RE: St. Lucie Units 1 and 2
Docket Nos. 50-335 and 50-389
Proposed License Amendments
Main Steam and Pressurizer Code Safety Valve
Setpoint Setting and Setpoint Testing Requirements

Attachment 1 is an evaluation of the proposed changes. Attachment 2 is the "Determination of No Significant Hazards Consideration." Attachments 3 and 4 contain copies of the affected Technical Specifications pages marked up to show the proposed changes.

ST. LUCIE UNIT 1 MARKED UP TECHNICAL SPECIFICATION PAGES

ST. LUCIE UNIT 2 MARKED UP TECHNICAL SPECIFICATION PAGES

TABLE 4.7-1

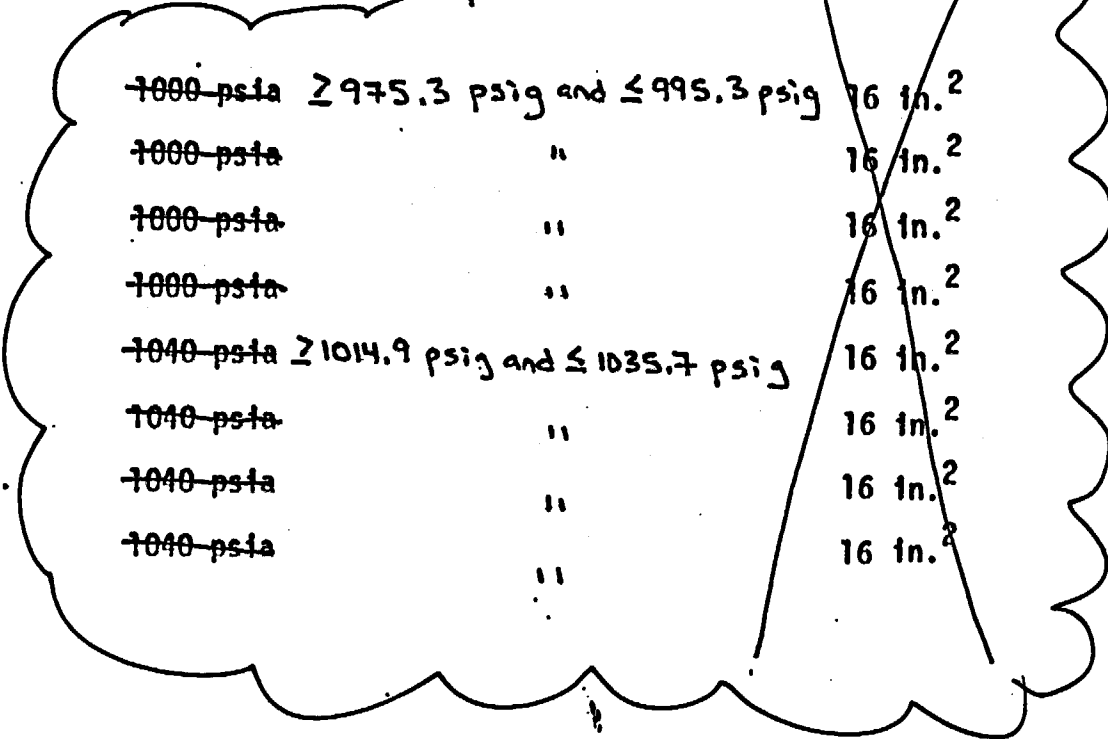
In addition to the above changes, the MSSV orifice size is being deleted from Table 4.7-1 (Unit 1) and Table 3.7-2 (Unit 2). The orifice size is a design feature that cannot be changed without a formal modification to the valves. The STS do not include valve orifice size requirements.

The MSSV orifice size data is being deleted from Table 4.7-1 (Unit 1) and Table 3.7-2 (Unit 2). While it is appropriate for the Technical Specifications to identify safety valve setpoints and to provide surveillance testing to ensure proper valve performance, safety valve orifice size is a passive, fixed design feature that cannot "drift" or otherwise be changed without a formal modification to the valves. There is no existing TS Surveillance associated with this design feature and the STS do not include valve orifice size requirements. As such, it is acceptable to delete this unnecessary detail from the Technical Specifications.

AS-LEFT LIFT SETTING ($\pm 1\%$)

1000 psia	≥ 975.3 psig and ≤ 995.3 psig	16 in. ²
1000 psia	"	16 in. ²
1000 psia	"	16 in. ²
1000 psia	"	16 in. ²
1040 psia	≥ 1014.9 psig and ≤ 1035.7 psig	16 in. ²
1040 psia	"	16 in. ²
1040 psia	"	16 in. ²
1040 psia	"	16 in. ²
